Access Compliance Report

Public Rights-of-Way

(Pedestrian Signals)

Intersection ID: N/A	Main Street:	Cross Street: N/A	Location: N/A
ADA ID: B73700142DC3	Signal Type: Two Push Buttons-Non APS	Overall Compliance: No	Severity Score: BTN 1:N/A BTN 2: N/A No BTN: N/A
Codes/Mitigation Info/Possible Solution		Field Measurements/Component Compliance

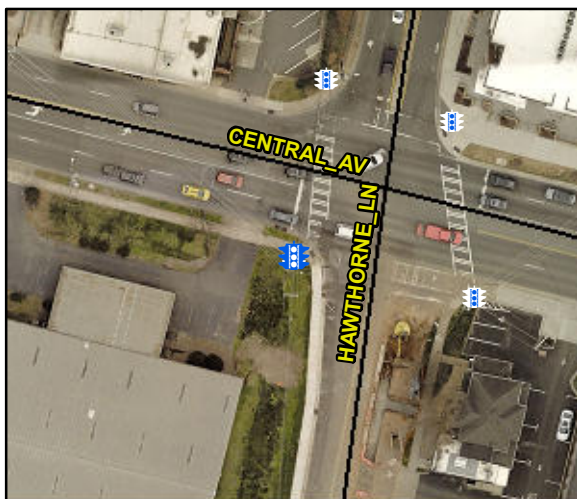
Surveyor Notes: TEXT HT 3/8

No	B 1 Clear Xing Direction?	NotClearlyMarked	No	B 2 Clear Xing Direction?	NotClearlyMarked
	B 1 Crossing Direction	To E		B 2 Crossing Direction	To N
Yes	B 1 DistanceTo XWalk (in)	27.0	Yes	B 2 DistanceTo XWalk (in)	45.0
No	B 1 DistanceTo Curb (in)	125.0	No	B 2 DistanceTo Curb (in)	132.0
Yes	B 1 Diameter (in)	2.0	Yes	B 2 Diameter (in)	2.0

Possible Solutions: Replace Signal Push Button With APS Button on New Post. Remove & Replace Sign.
